Access Compliance Report Public Rights-of-Way (Curb Ramps)

Main Street: REDBERRY_RD		Cross Street: BROWNING_AVE		Location:	S
ADA ID: RPRK211014131157	Ramp Type:Type 1 - Perpendicular Diagonal Initial Pass/Fail: Fail		Overall Compliance: No	Severity Score:	2

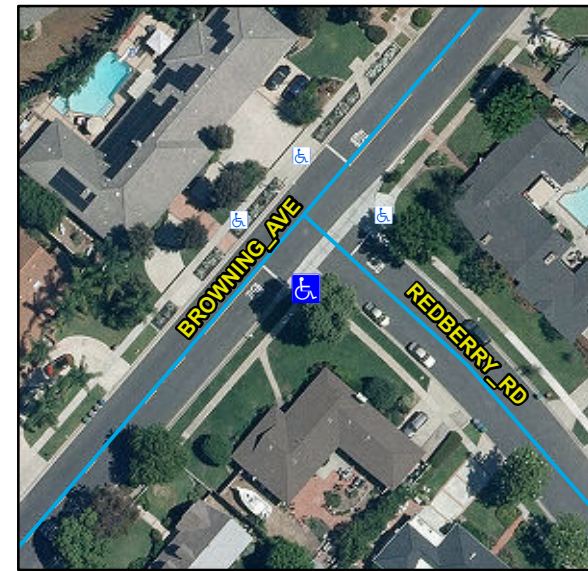
Compliance	Description	Data	Compliance	Description	Data
N/A	Ramp Length (in)	117	N/A	Flare Type LT	
Yes	Ramp Width (in)	48			N/A
Yes	Ramp Run Slope (%)	8.3	N/A	Flare Slope LT (%)	N/A
No	Ramp Cross Slope (%)	3.3	N/A	Flare Traversable LT	N/A
N/A	Landing Present	N/A	N/A	Flare Type RT	
N/A	Landing Length (in)	N/A			N/A
N/A	Landing Width (in)	N/A	N/A	Flare Slope RT (%)	N/A
N/A	Landing Run Slope (%)	N/A	N/A	Flare Traversable RT	N/A
N/A	Landing Cross Slope (%)	N/A	N/A	DWS Provided	N/A
N/A	Landing Movement Obstructed?	N/A	N/A	DWS Contrast	N/A
	Landing Movement Type	N/A	N/A	DWS Length (in)	N/A
N/A	Landing Shared	N/A	N/A	DWS Full Width	N/A
N/A	Clear Space	Yes	N/A	DWS Offset Left (in)	N/A
N/A	Clear Space To Crosswalk (in)	N/A	N/A	DWS Offset Right (in)	N/A
N/A	Marked Crosswalk 1	No	N/A	Marked Crosswalk 2	No
	Crossing 1 Direction	NE		Crossing 2 Direction	NW
	Marked Crosswalk 1 Width (in)	N/A		Marked Crosswalk 2 Width (in)	N/A

N/A	Ramp Inside Crosswalk 1	N/A	Yes	Ramp Inside Crosswalk 2	N/A
	Crossing 1 Slope (%)	7.9		Crossing 2 Slope (%)	11.7
	Crossing 1 Cross Slope (%)	4.4		Crossing 2 Cross Slope (%)	0.3
N/A	Gutter Ponding	N/A	No	Curb Slope	10.9
Yes	Gutter Lip Height (in)	0		Road Run Slope (%)	3.1
N/A	Gutter Run Slope (%)	N/A		Road Cross Slope (%)	2.4
N/A	Gutter Cross Slope (%)	N/A			
Yes	Overall Surface Condition: Acceptable		Yes	Perp Joint Present	Yes
	Cross Gutter Present?	Yes		Spandrel Present?	Yes
	Replace Cross Gutter?	No		Replace Spandrel?	No

Remove & Replace Curb Ramp With Two New Directional Ramps or Equivalent.

R304.2.2, R304.5.3, STD 1115
